Zoning & Subdivision Committee
Tuesday, September 6, 2016, 1:30 pm

Staff Report – Village Neighborhood Section 4 Phase 1

**Subject: Village Neighborhood, Section 4, Phase 1
Final Plat Review – Comment Letter #1**

**Subject: The Courtyards at Jerome Village, Phase 1
Final Plat Review – Comment Letter #2**

PRELIMINARY PLAT SITE PLAN

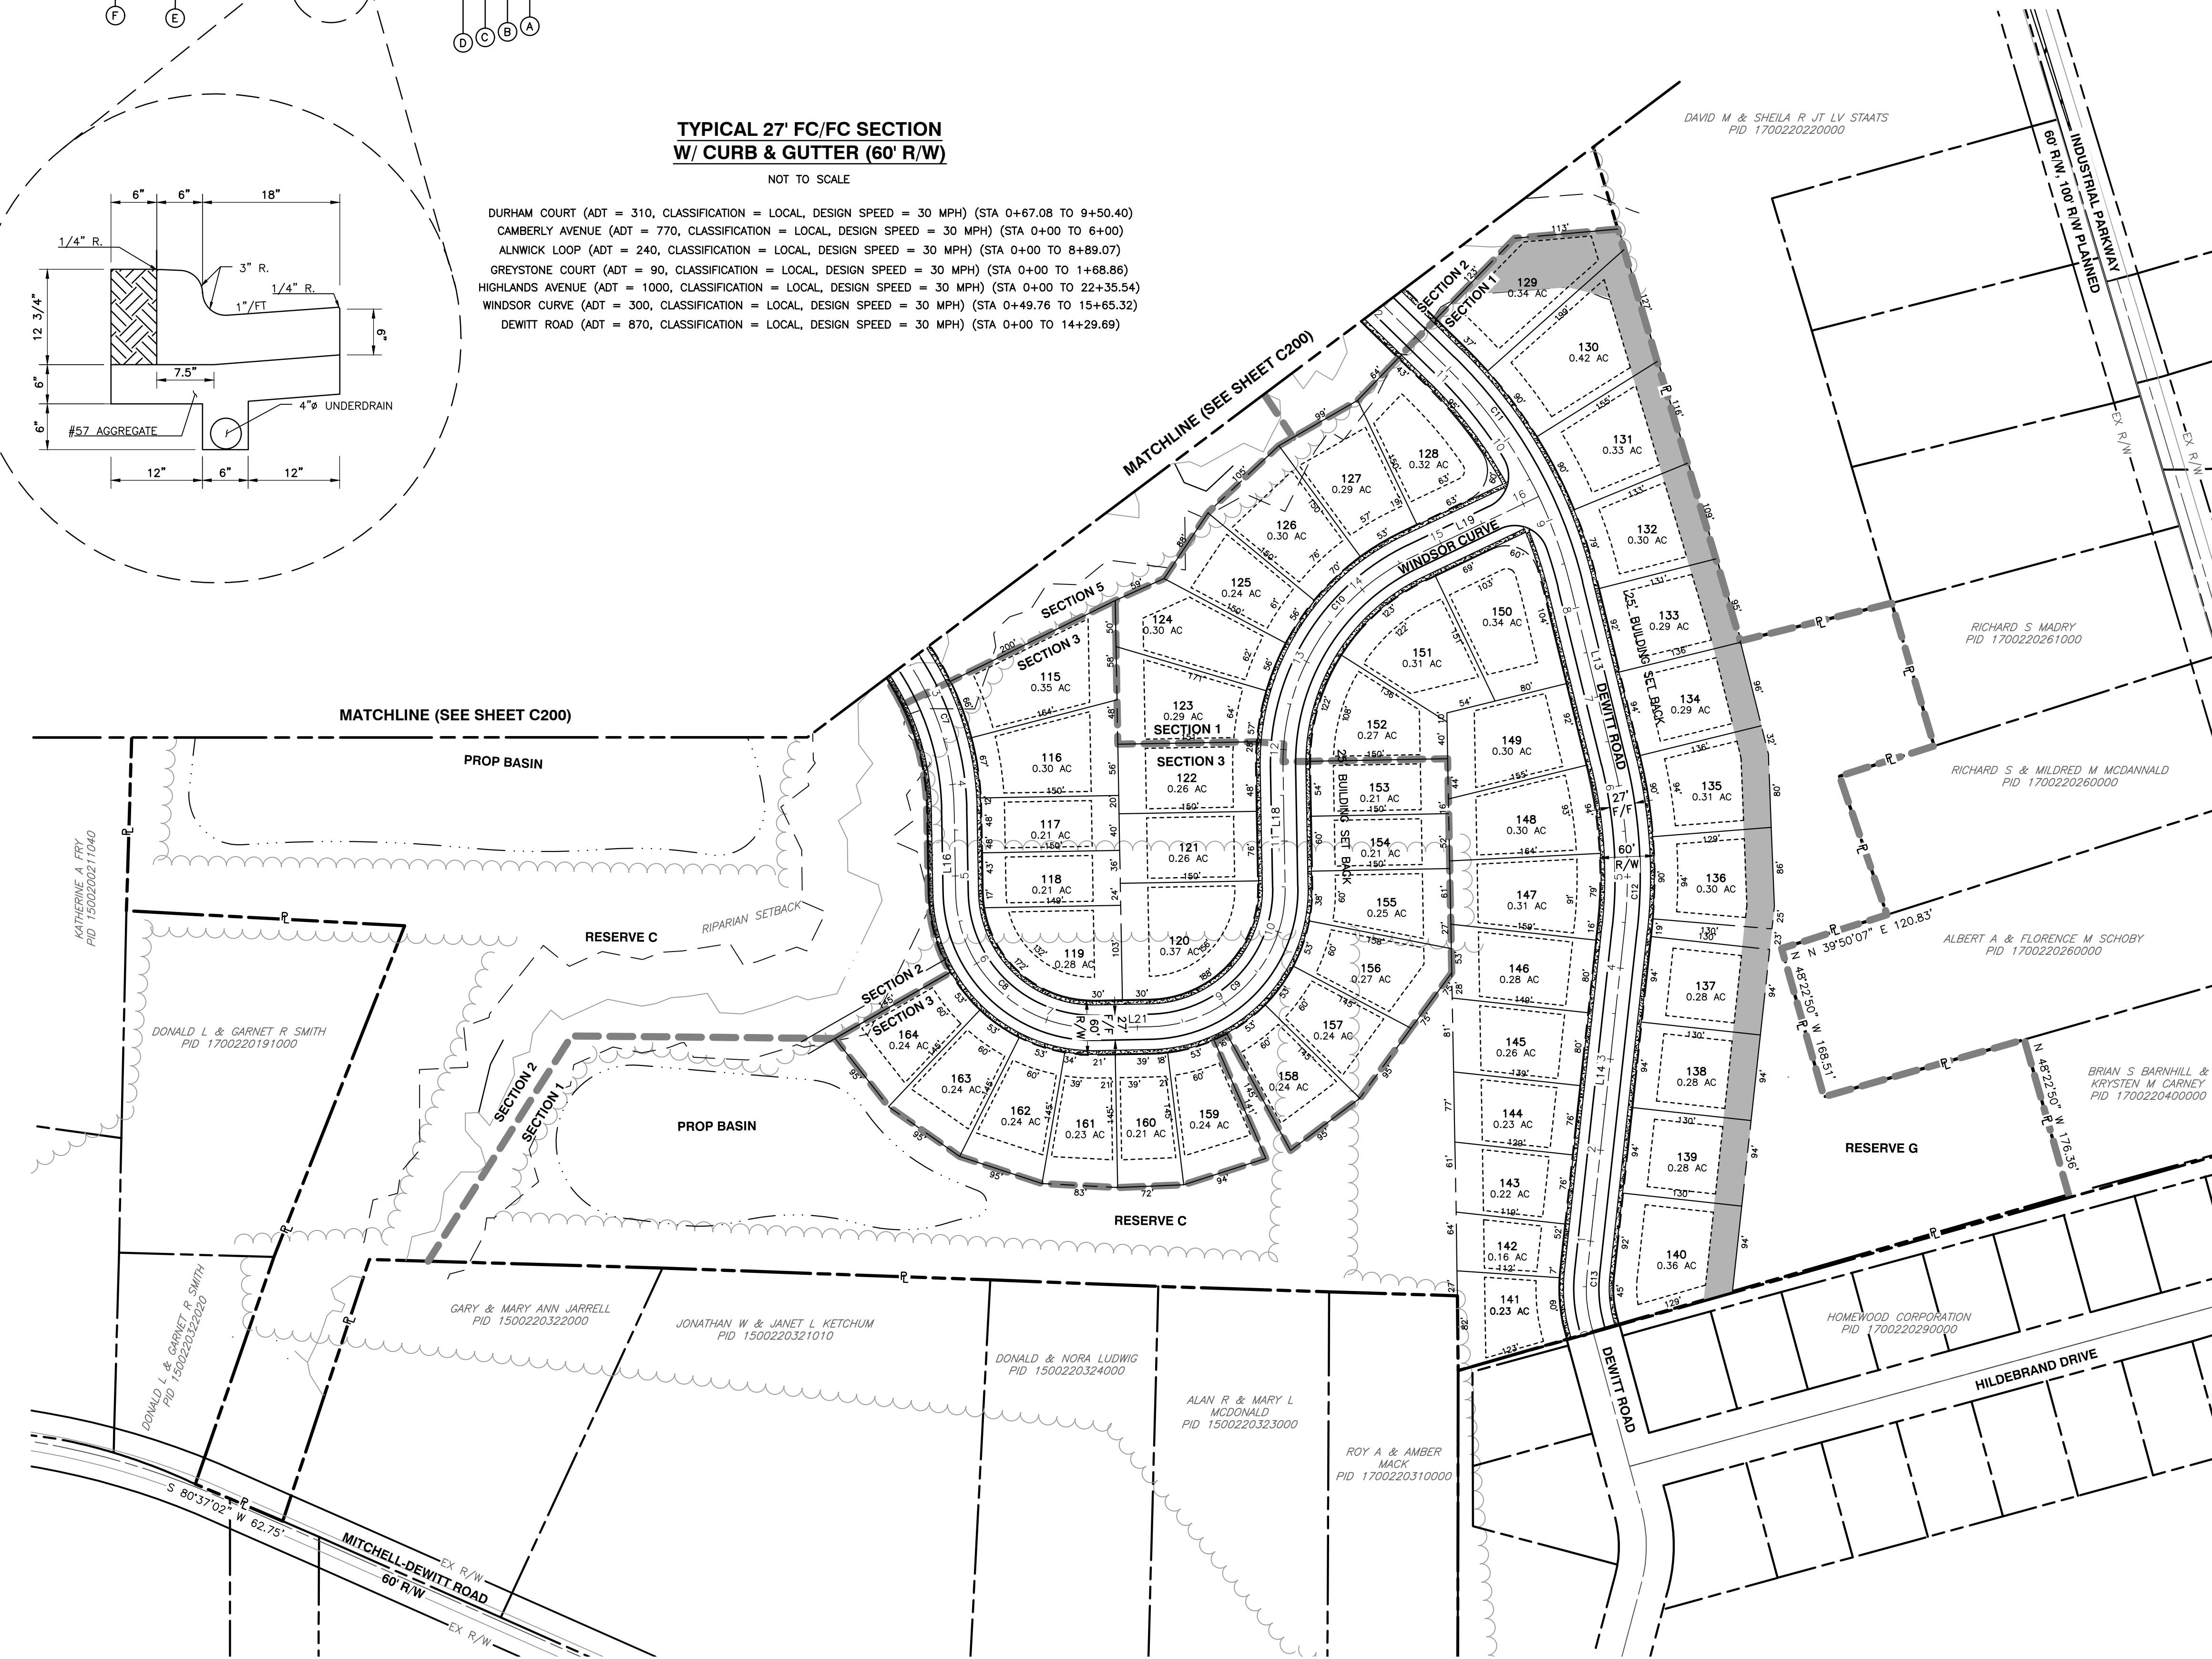
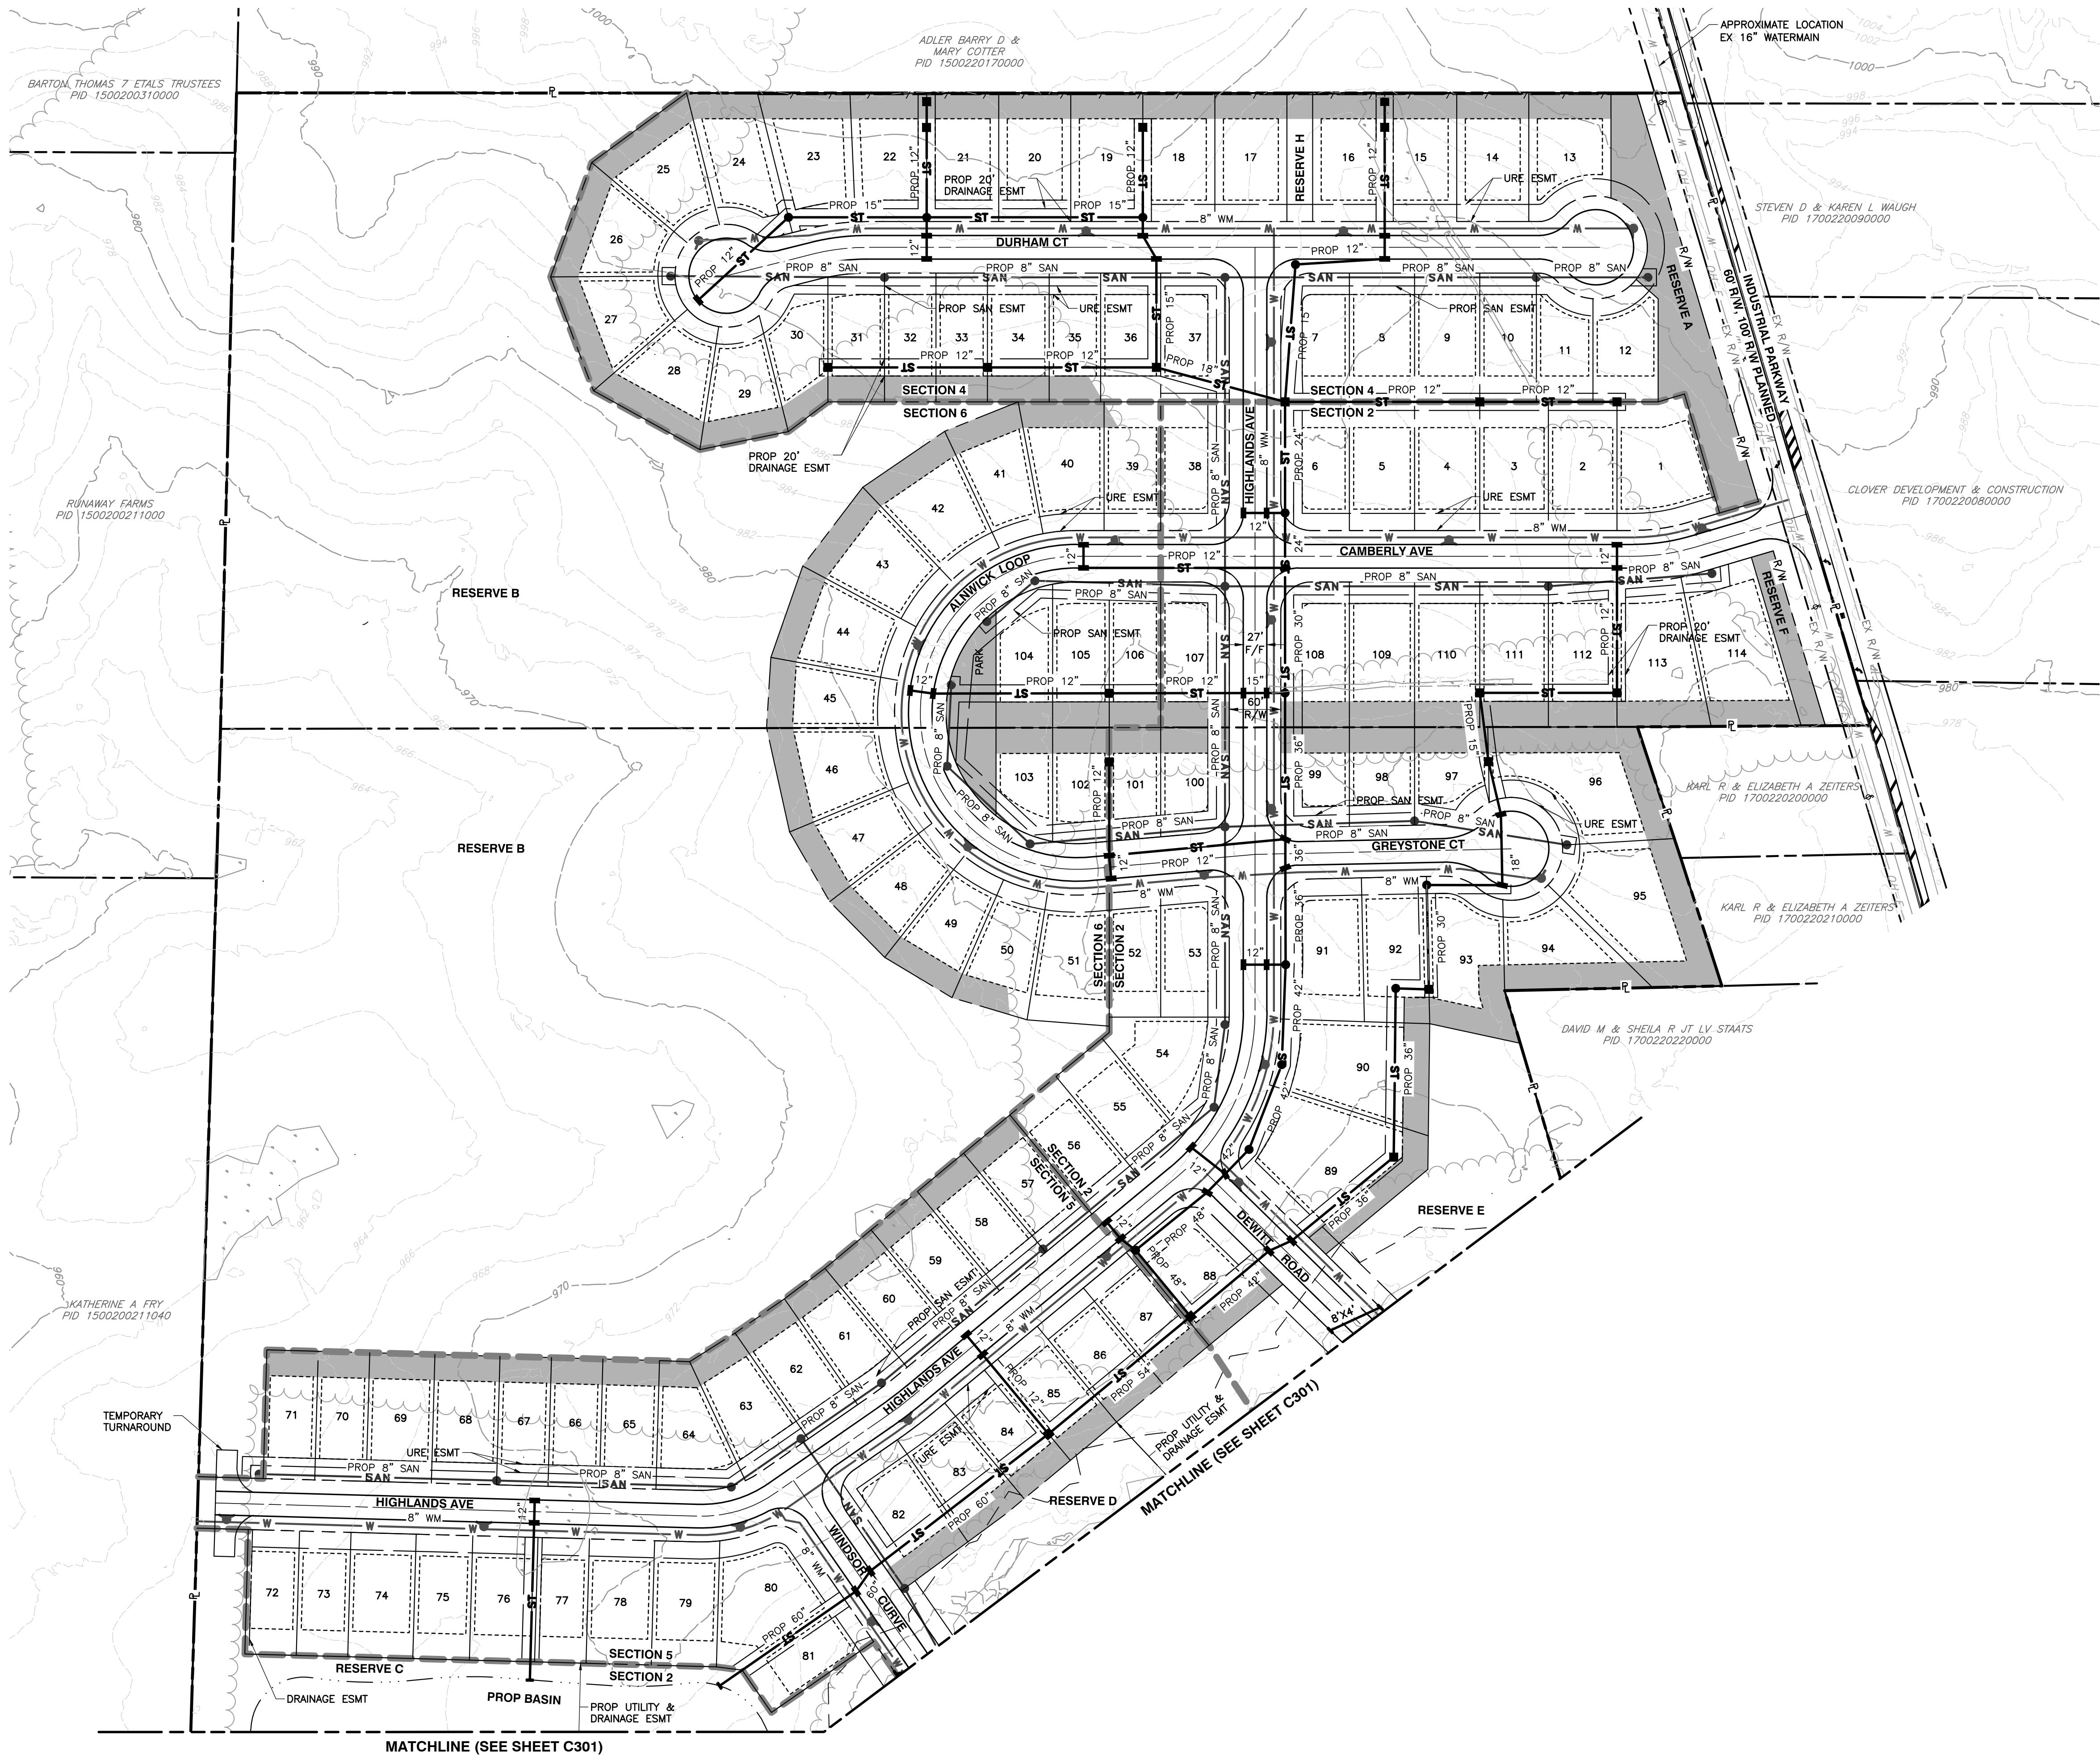
- 3) Sheet 3 of 12 – C200 – Site Plan
 - g) Based on the locations of trees or mounding URE request easements along the front lots on both sides of the streets.

- 4) Sheet 4 of 12 – C201 – Site Plan
 - i) Based on the locations of trees or mounding URE request easements along the front lots on both sides of the streets.

DRAWING NO.:	C300		
DATE:	AUGUST 2016	DRAWN BY:	NSS
DWG SCALE:	1"=100'	CHECKED BY:	MCR
PROJECT NO.:	182-554	APPROVED BY:	CLL

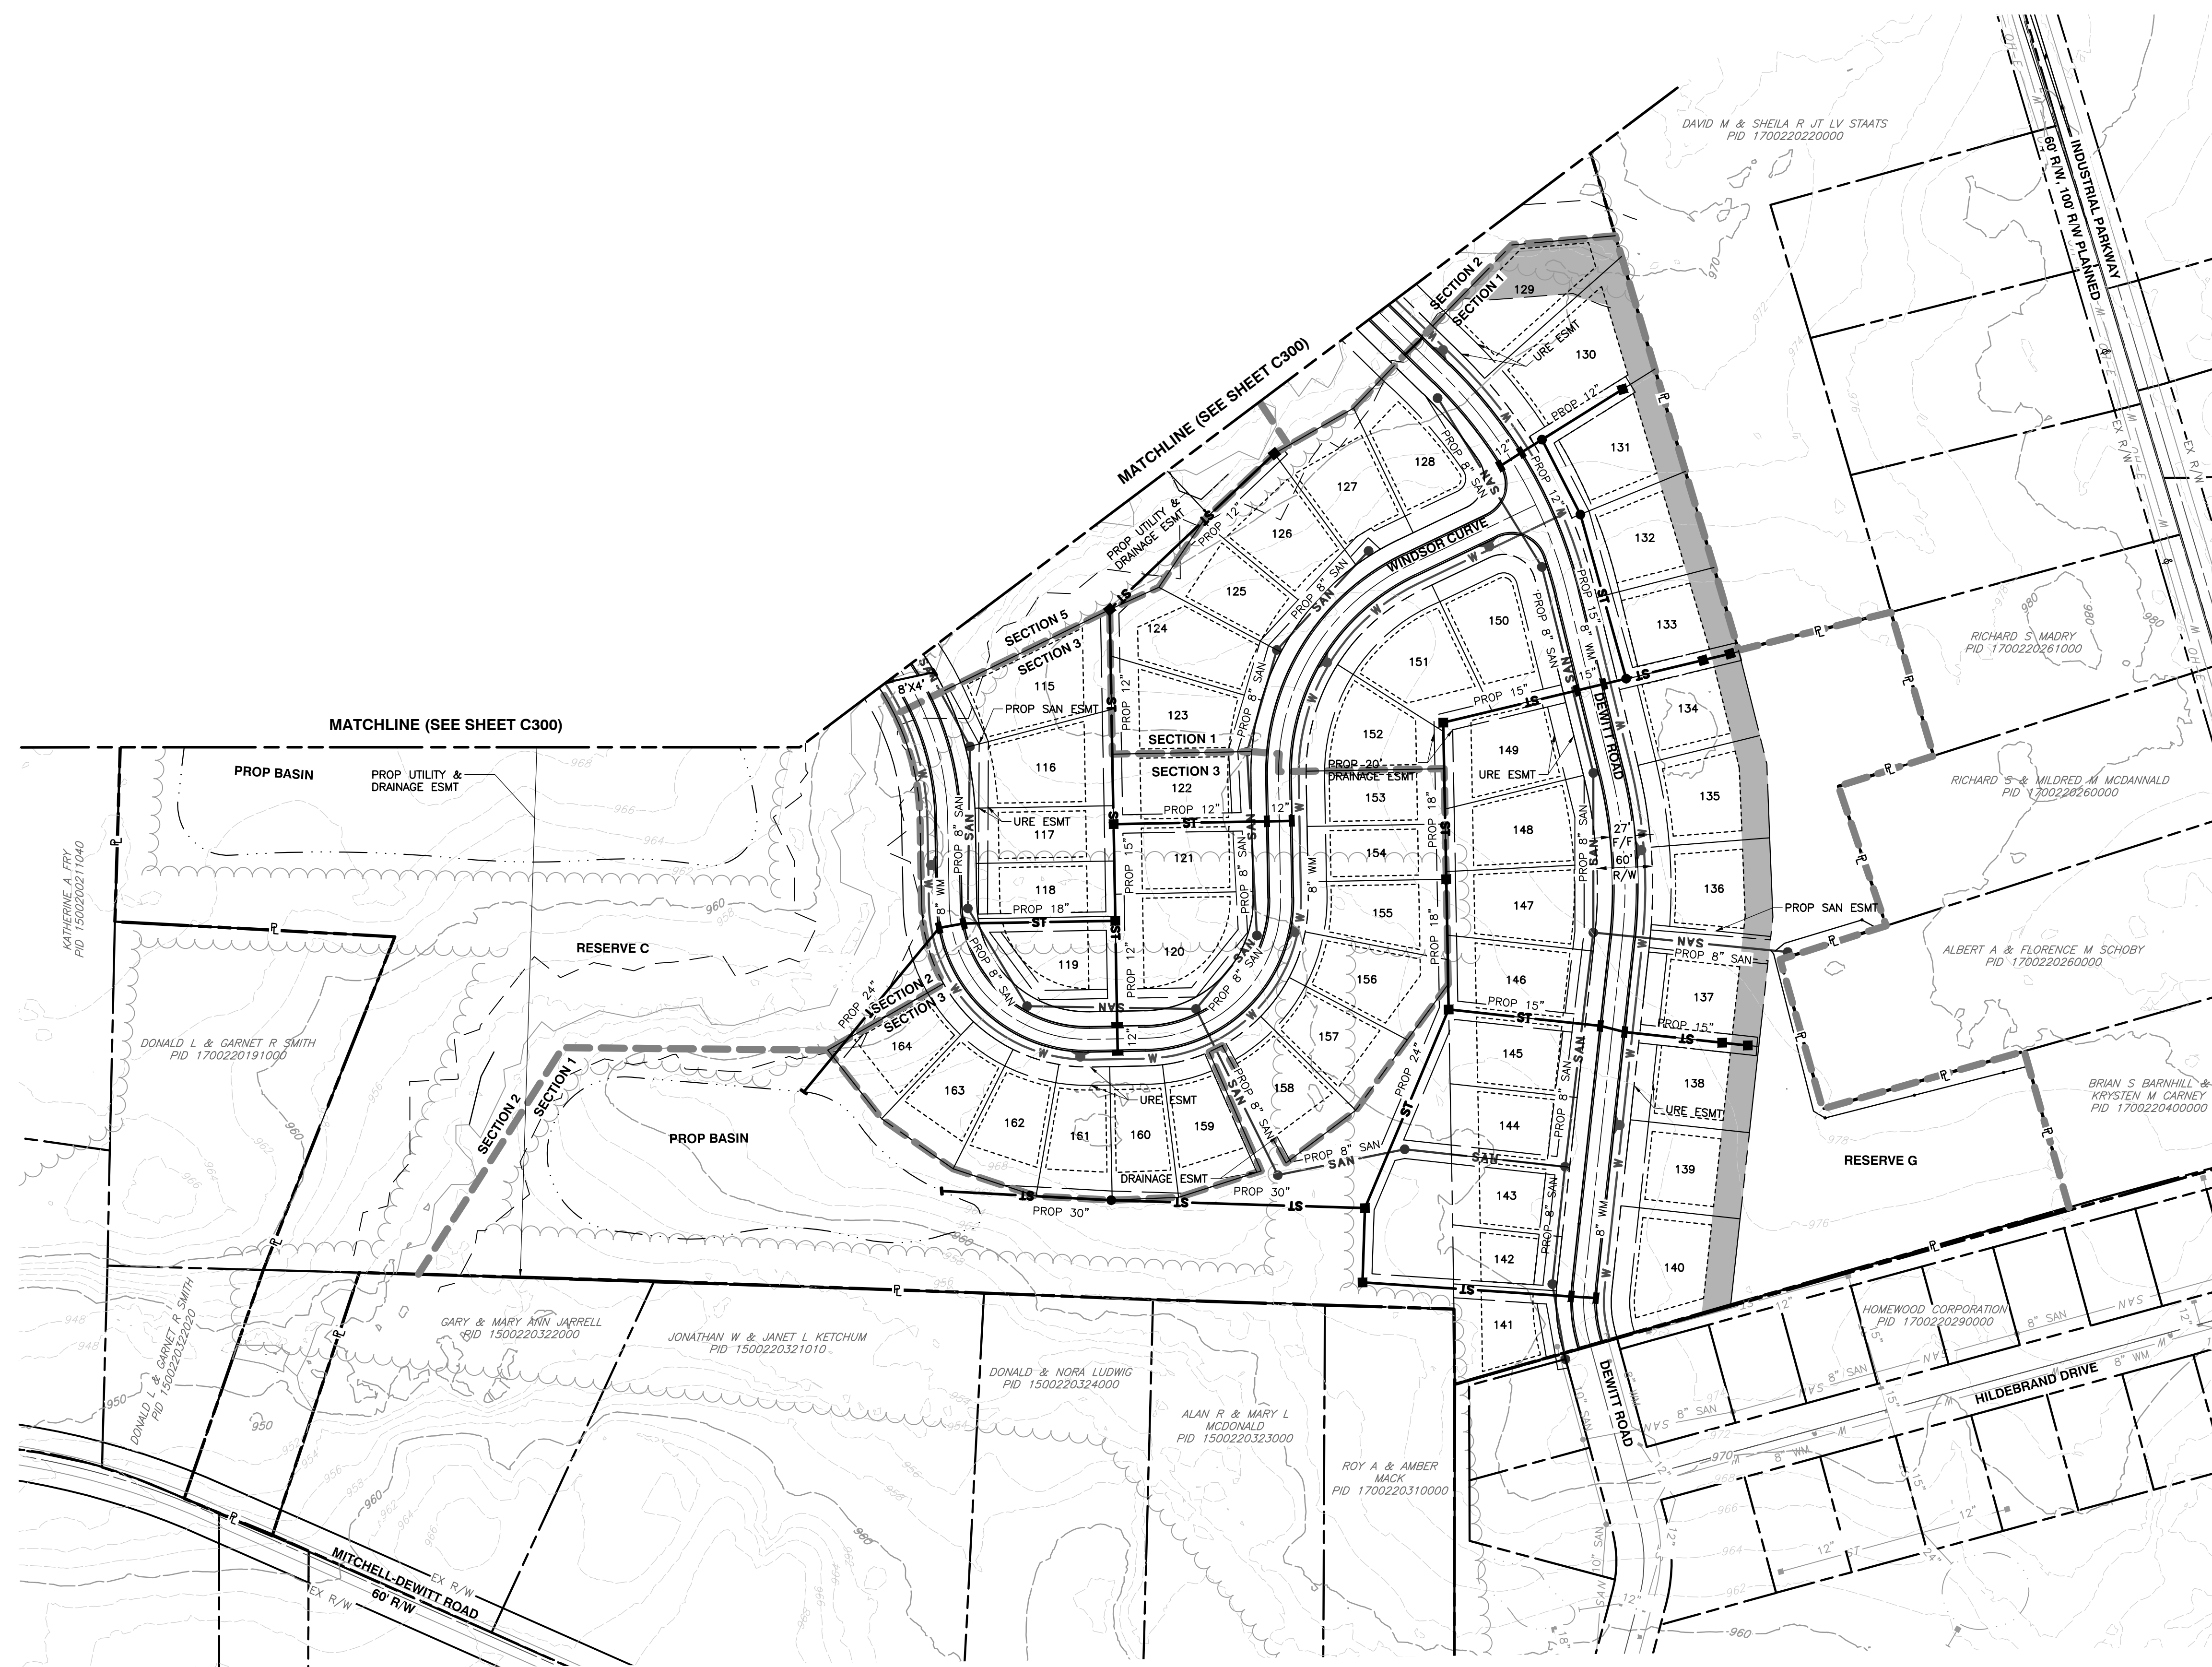
- 5) Sheet 5 of 12 – C300 – Utility Plan
 - j) URE require 30 feet electric easement onto development along Industrial Pkwy (CR1) adjacent to proposed Road R-O-W for existing 3 phase overhead electric facilities relocation. Reference Reserve A and F.
